# Technical Service Bulletin

SUBJECT:		No:	<b>TSB-21-42A-011REV</b>
<b>MODIFIED HOOD FOR HOOD FLUTTER - 2022 OUTLANDER - REVISED</b>		DATE:	<b>December 2021</b>
		MODEL:	<b>2022 Outlander</b>
<b>CIRCULATE TO:</b>	<input type="checkbox"/> GENERAL MANAGER	<input checked="" type="checkbox"/> PARTS MANAGER	<input checked="" type="checkbox"/> TECHNICIAN
<input checked="" type="checkbox"/> SERVICE ADVISOR	<input checked="" type="checkbox"/> SERVICE MANAGER	<input checked="" type="checkbox"/> WARRANTY PROCESSOR	<input checked="" type="checkbox"/> SALES MANAGER

*This bulletin supersedes TSB-21-42A-011, issued December 2021 and explains how to verify reinforced versus non reinforced hoods and also advises of VIN clean point NZ051835 for production line installation of the reinforced hood. Revisions are italicized and indicated by ◀.*

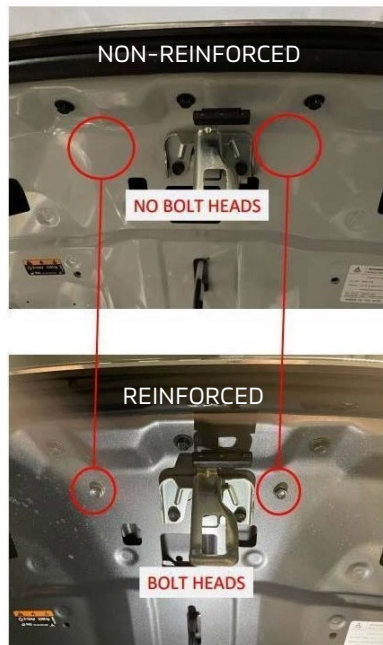
For customers that express concerns with hood fluttering, the hood should be replaced with a new modified hood (65100W080P).

A change in the weather strip from a full clip style attachment to a new style which requires installation over the front lip of the hood, has also been made. The new weather strip (65820W020P) should be installed prior to re-installation of the grill (from original hood).

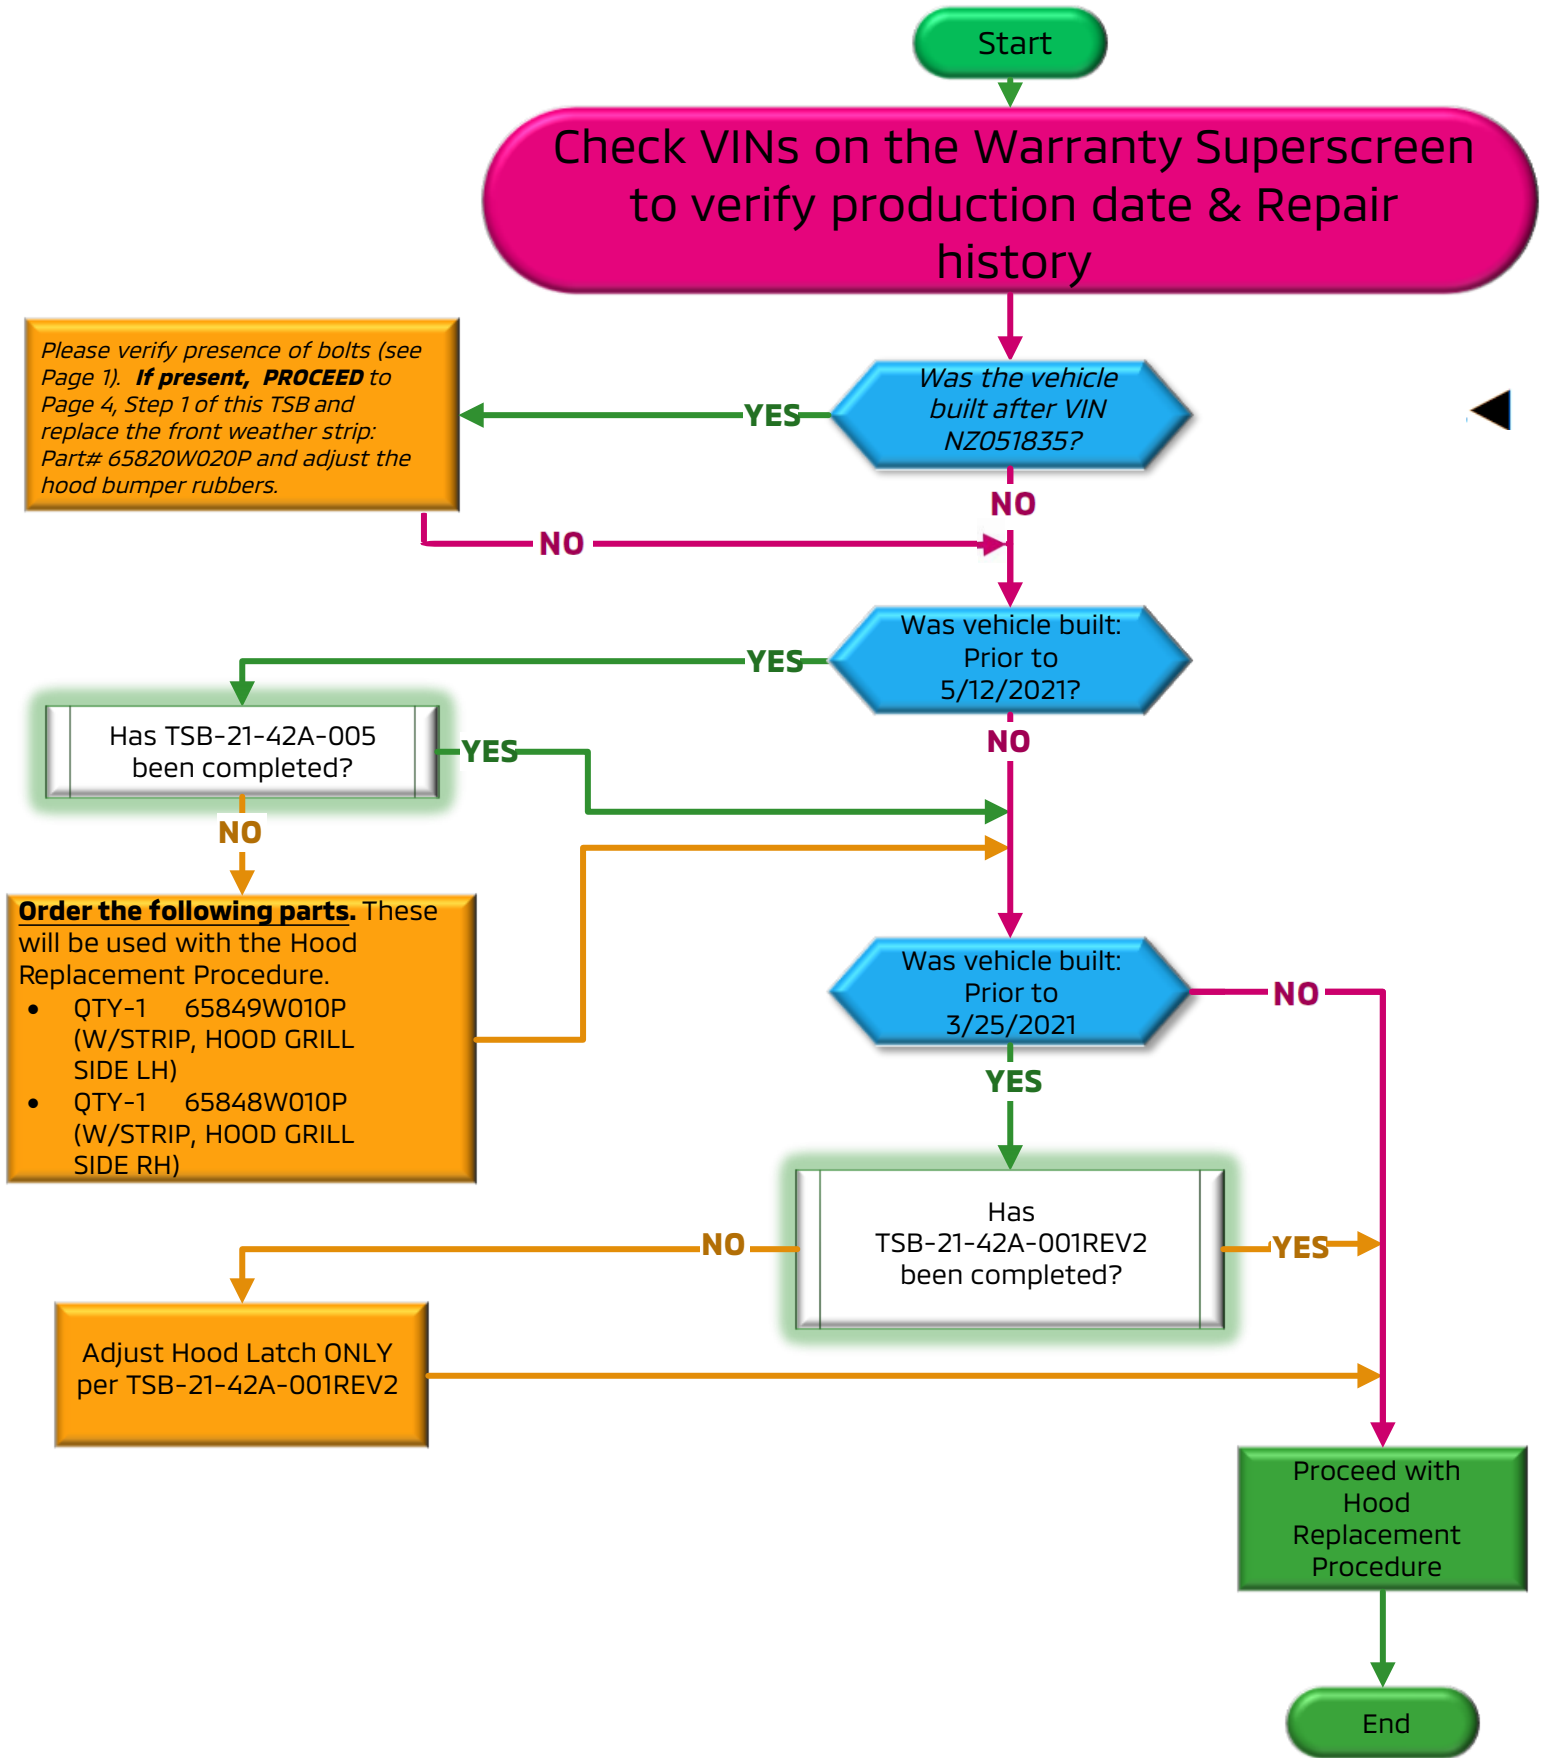
*Method to determine if hood is reinforced (bolt heads) or non-reinforced (no bolt heads):* ▶

Please refer to the flow chart (page 2 of this bulletin) prior to proceeding with the procedure to determine/confirm the next appropriate steps.

Image 1

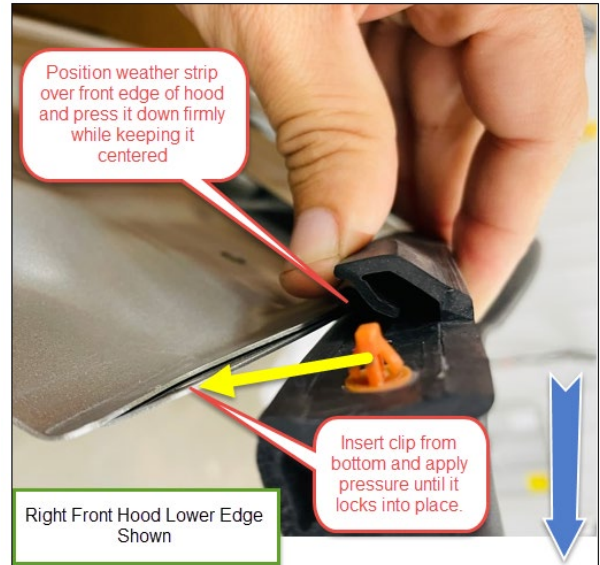
**NOTE:** For *front end weather strip only installation* the entire grill assembly does not need to be removed (see image 4). Remove mounting bolts from back side of grill and loosen clips on the bottom. Lift grill up and insert weather strip as shown.
